Enclosed are the Department's comments on the draft NRC document on far-field groundwater modeling. This document was provided by Robert J. Wright's April 20, 1982, transmittal letter to R. A. Deju.

Review of NRC Draft Document

COMMENTS ON NRC DRAFT DOCUMENT ON BASALT  
FAR-FIELD MODELING

FIGURE 1.

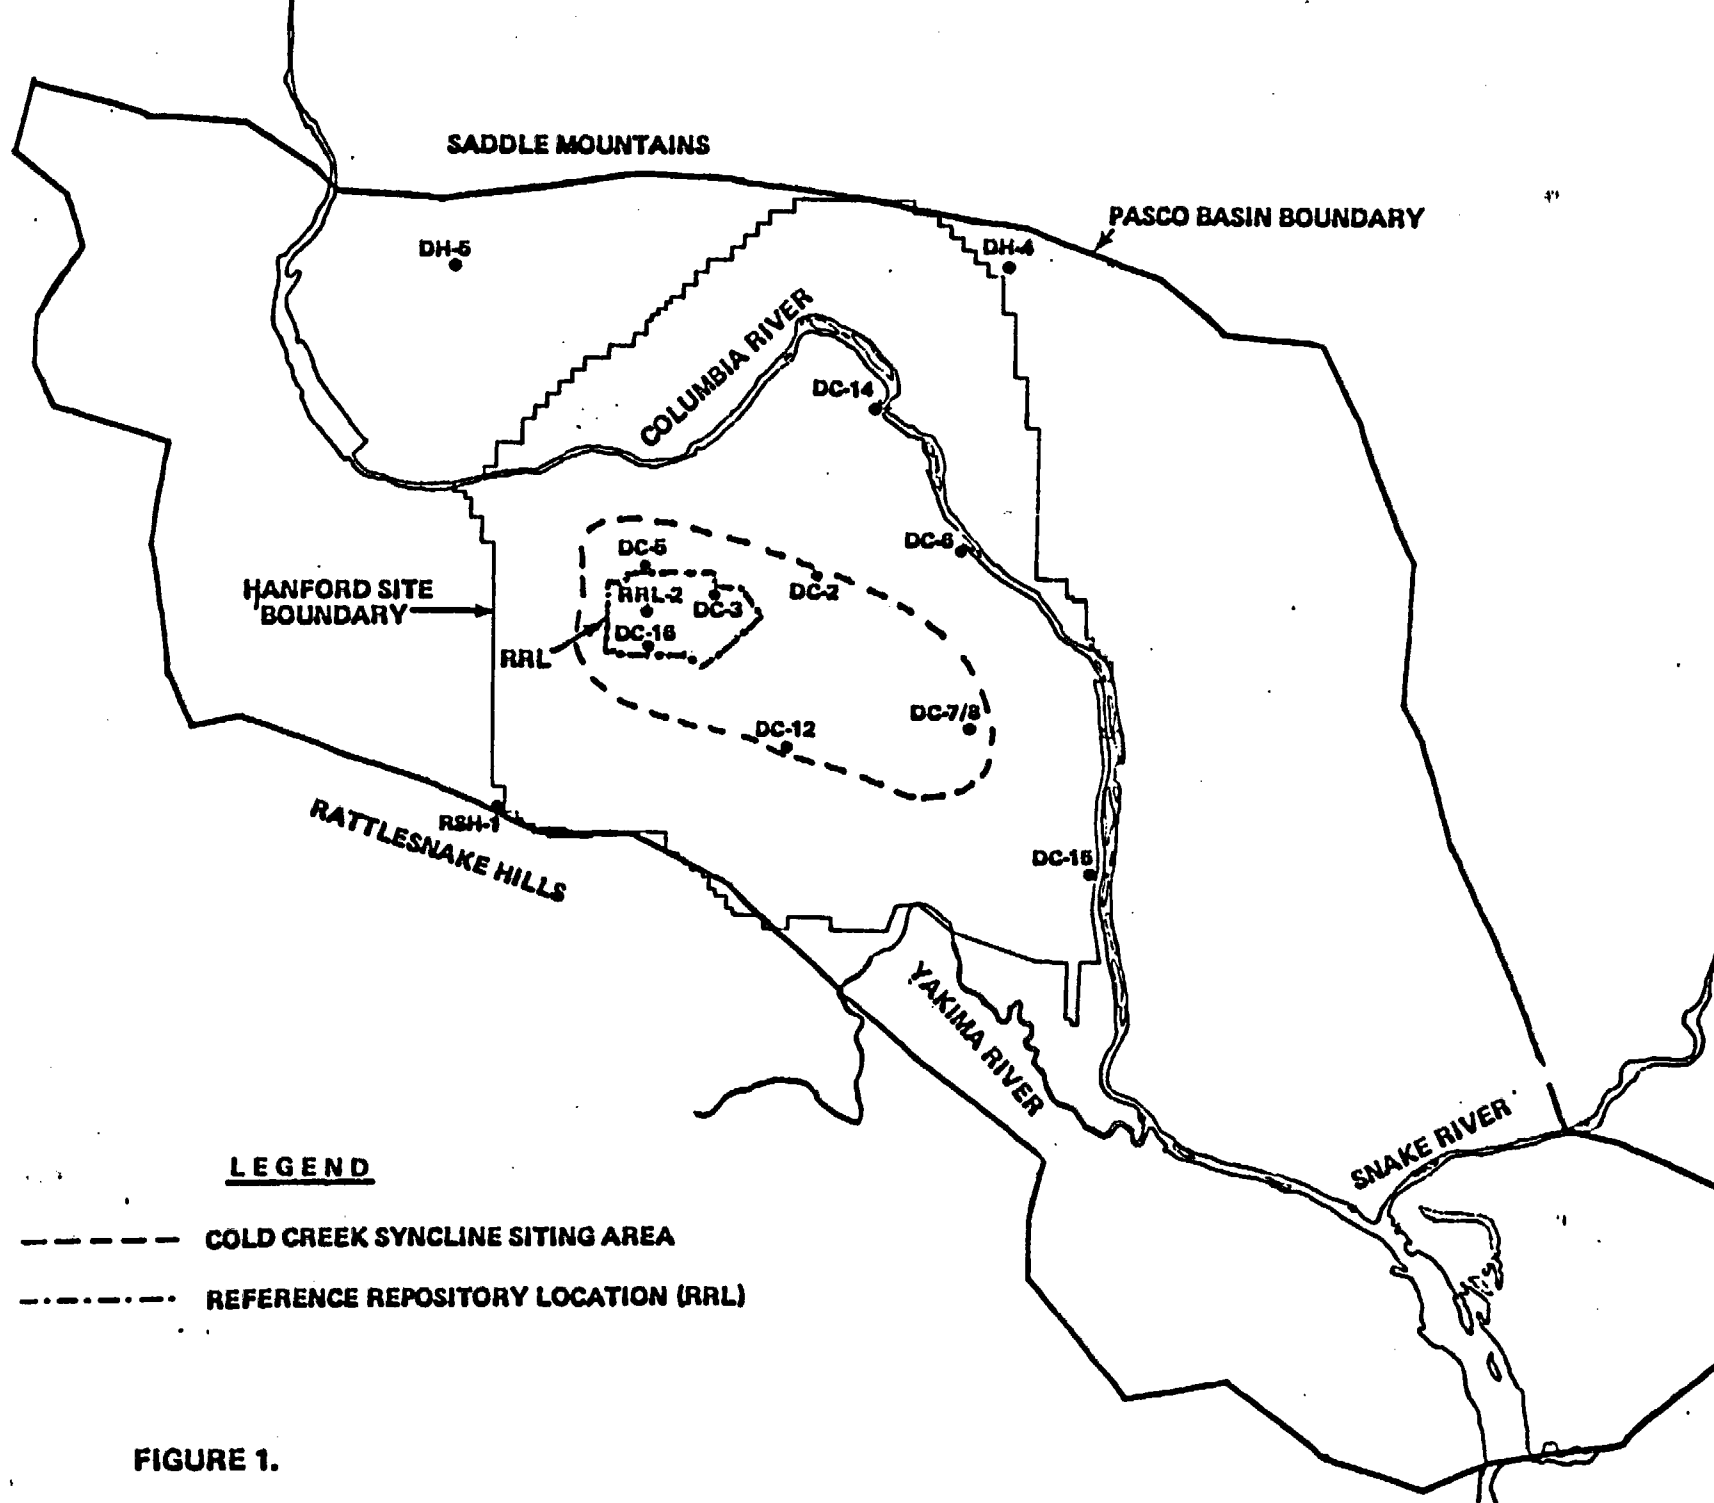
2. The second major difference was described on Page 37 and 39 as follows: "Rockwell set the head at the bottom of the Grande Ronde to 550 ft. above sea level for approximately 42 miles along the northern basin boundary. No-flow boundaries were assigned to all units above this; thereby restricting flow from entering the basin from the north. PNL assigned a flow boundary along this same area. Head values ranged from 675 to 880 feet above sea level - increasing to the east. No-flow boundaries were assigned to the Saddle Mountains Formation only. The head difference between the two models ranged from 125 feet to 330 feet."

Recently we have uncovered some very pertinent hydraulic head data deep in the Grande Ronde Basalts at Borehole DH-5 (see attached Figure 1). A single piezometer tube was set at a depth of 4854 feet below land surface. Bottom of the hole was 5002 feet below land surface. Head measurements were taken in 1972 and 1973 by the USGS and in 1975 and 1976 by the Atlantic Richfield Hanford Company (predecessor of Rockwell). In all cases the head was steady at 548 feet MSL. By comparison, the Rockwell model reported in LD-44 showed a head at the DH-5 location of 549 feet MSL whereas the PNL model showed a head value of 614 feet MSL. The bottom of both models were at somewhat higher elevations than the borehole measurement interval.

FIGURE 2. DIGITIZED POTENTIAL SURFACE FOR THE GRANDE RONDE BASALT. CONTOUR LEVELS ARE IN FEET ABOVE MSL.

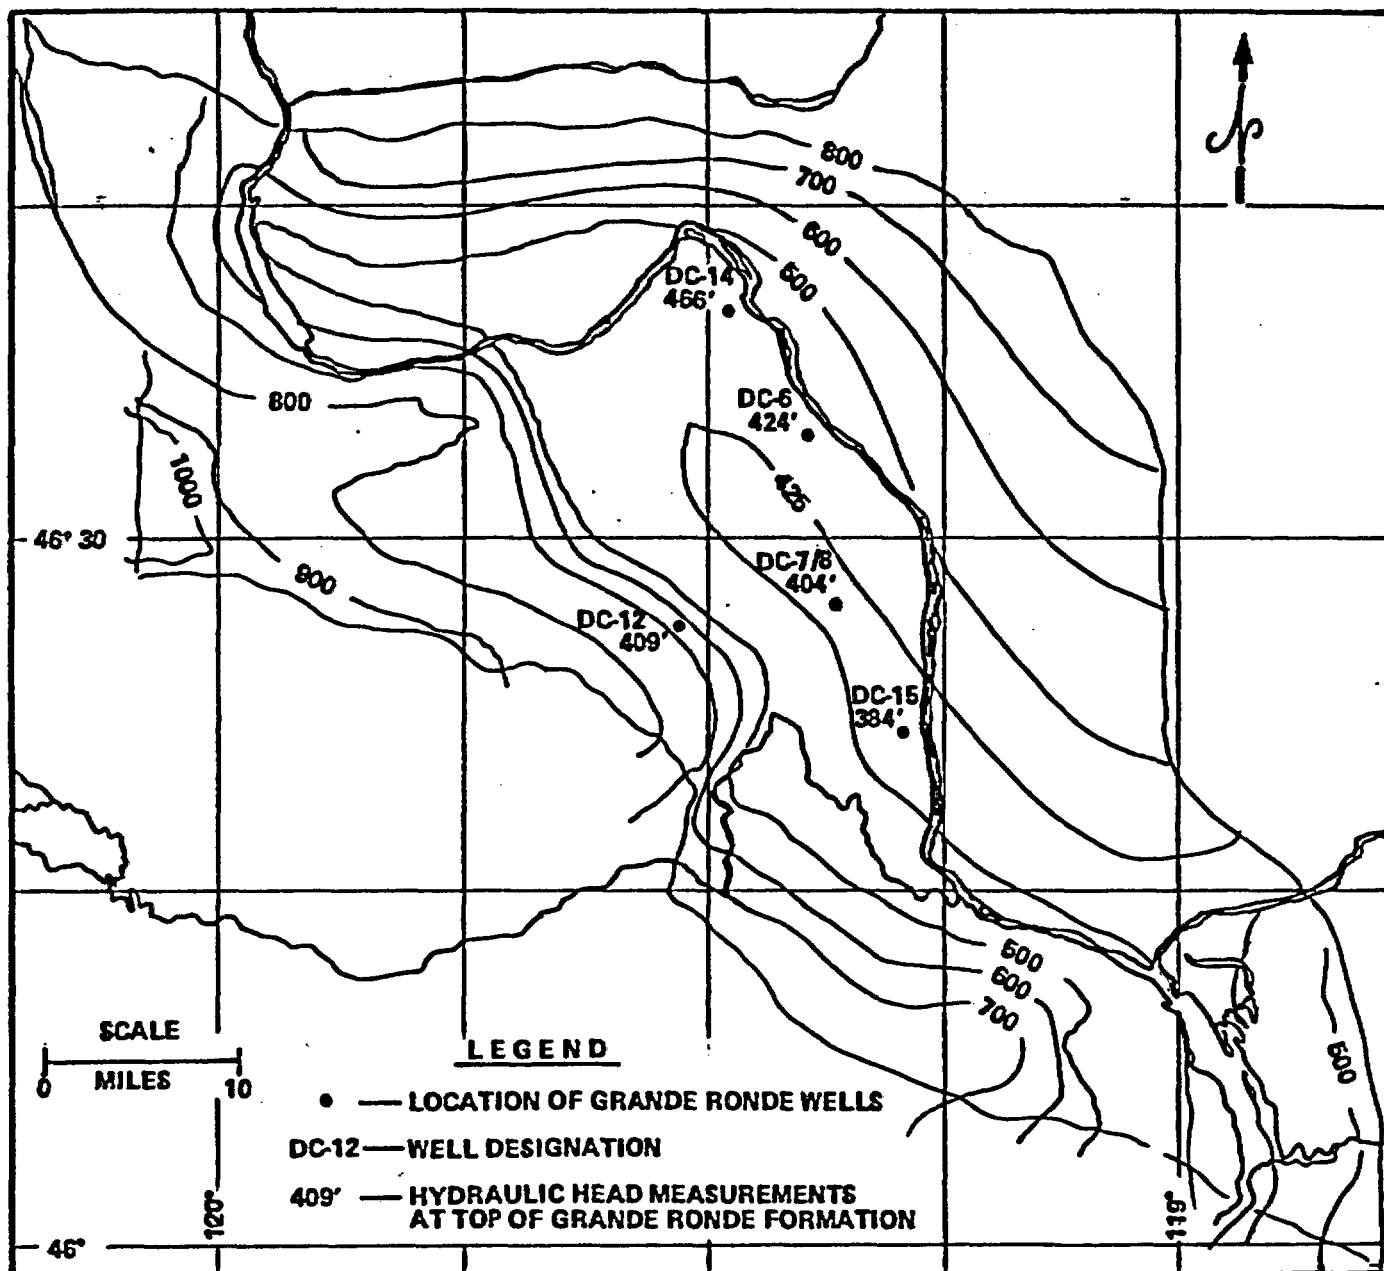
In our meetings with the NRC we have presented the position that the boundary conditions must be consistent with the head measurements within the model boundaries. This is particularly important with regards to the Grande Ronde Basalt head values. At the time the PNL study was performed, some of the key data used in the Rockwell study were not available. However, it should be noted that PNL did include an interpreted Grande Ronde Basalt potential surface in their report. This surface is presented on Page 4-111 (PNL Figure 27) of the March 1981 draft of the PNL report. If the head measurements at the top of the Grande Ronde formation from boreholes DC-7/8, DC-6, DC-12, DC-14, and DC-15 are plotted on that surface, a somewhat reasonable match is obtained except at borehole DC-12 (see attached Figure 2). However, if the interpreted potential surface (PNL Figure 27) is compared to the PNL predicted head surface at the top of the Grande Ronde (PNL Figure 41, Page 4-146) the model heads are substantially higher than the interpreted surface. The PNL model computed heads at the top of the Grande Ronde are more than 100 feet higher than the measurements taken subsequent to the PNL study (see attached Figure 3). Thus even with much higher ratios of vertical to horizontal hydraulic conductivity in the PNL model, it predicted much higher heads in the Grande Ronde than either the interpreted potential surface or observed heads. It seems clear that specified heads along some boundaries in the PNL model, particularly for the Grande Ronde formation, are too high. This resulted in vertical head gradients which are also much higher than observed in the central portion of the Hanford Site.

**FIGURE 3. MODEL PREDICTED HEADS FOR THE TOP OF THE GRANDE RONDE FOR THE BASE CASE (RUN 4) FOR THE CURRENT CONDITIONS SCENARIO. HEADS ARE REFERENCED TO MSL.**

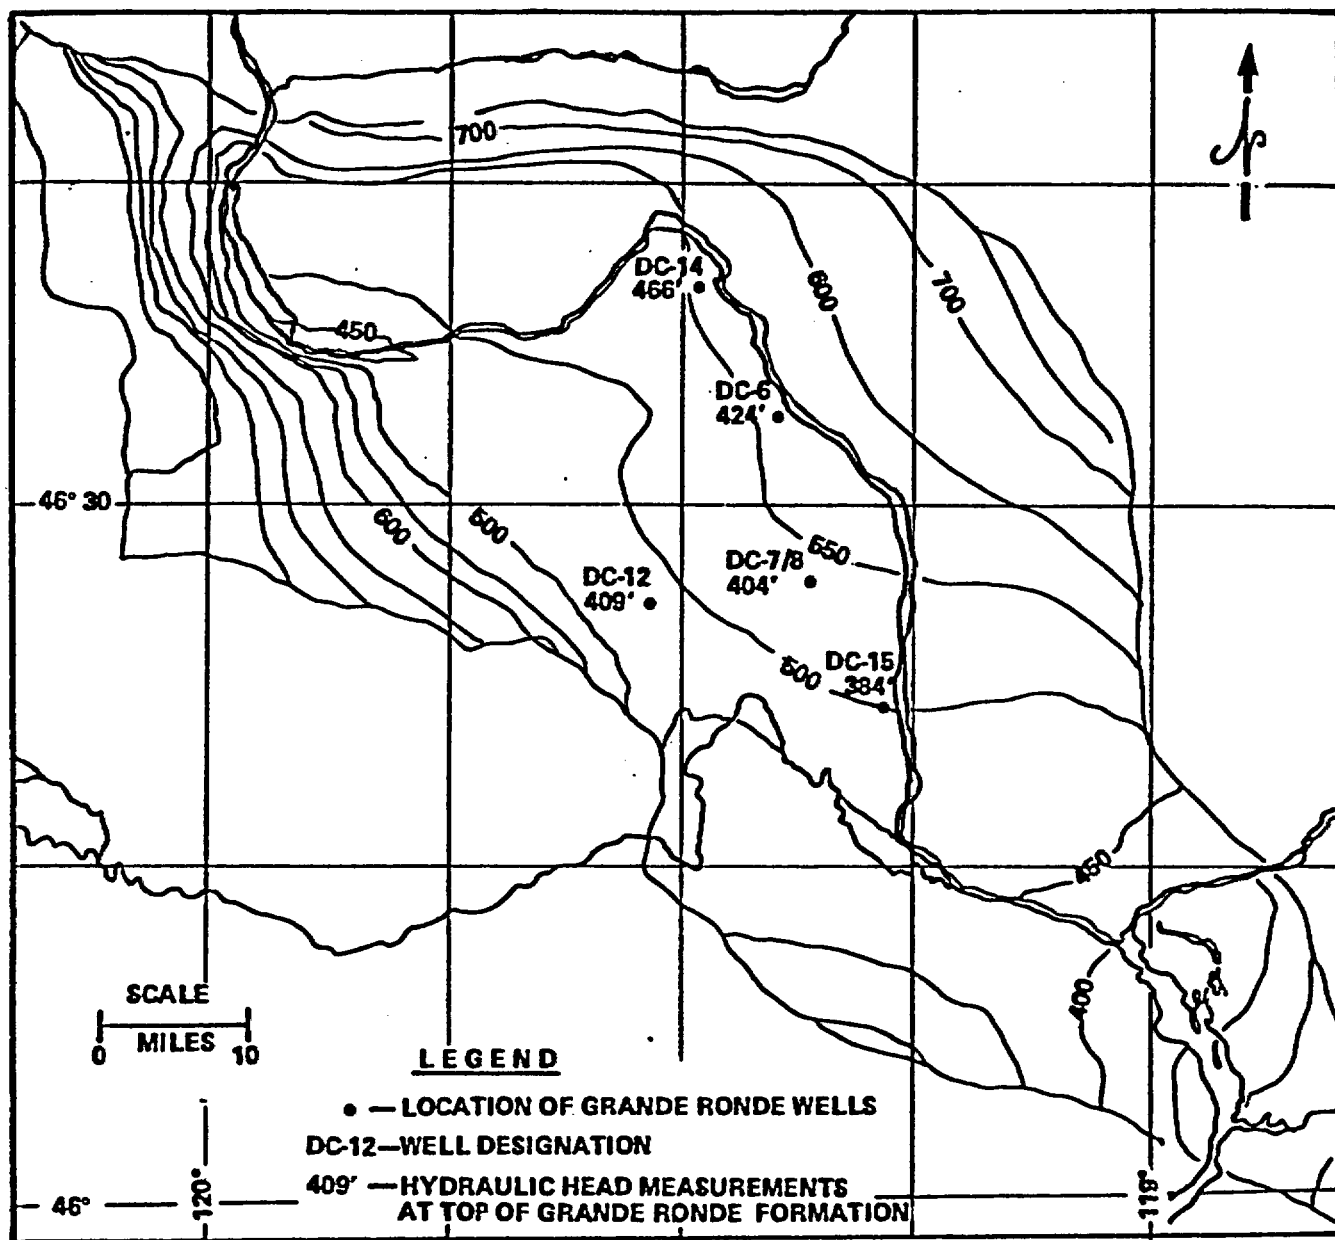
3. On Page 39 of the NRC draft report it is stated that "the RHO model does not permit an upward gradient in [the southwestern corner of the Pasco Basin, and therefore] no upward discharge can exist.- This is significant to RHO's conclusion that particles do not leave the Grande Ronde formation."

*as*  
The Rockwell model does produce an upward gradient in all formations in the area east of the Columbia River. A small upward gradient exists in the Grande Ronde formation even somewhat west of the Columbia River. This is true even with recharge conditions assigned to the Horse Heaven Hills boundary.
